Access Compliance Report

Public Rights-of-Way

(Curb Ramps)

Intersection ID: N/A	Main Street: WALTER_ST	Cross Street: WEST_AV	Location: NE
ADA ID: 526CD3FE2753	Ramp Type: PerpDiag	Initial Pass/Fail: Pass	Overall Compliance: No
Codes/Mitigation Info/Possible Solution		Field Measurements/Component Compliance

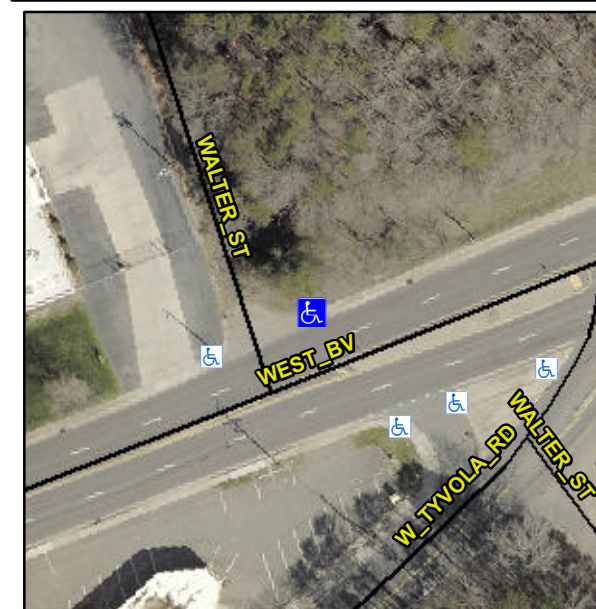
Not Found, R304.2.1, R304.2.2-Perp, R304.3.2-Para, R304.5.3, R305.1.4, R305.2, R302.7

Remove & Replace Curb Ramp With Two New Directional Ramps or Equivalent.
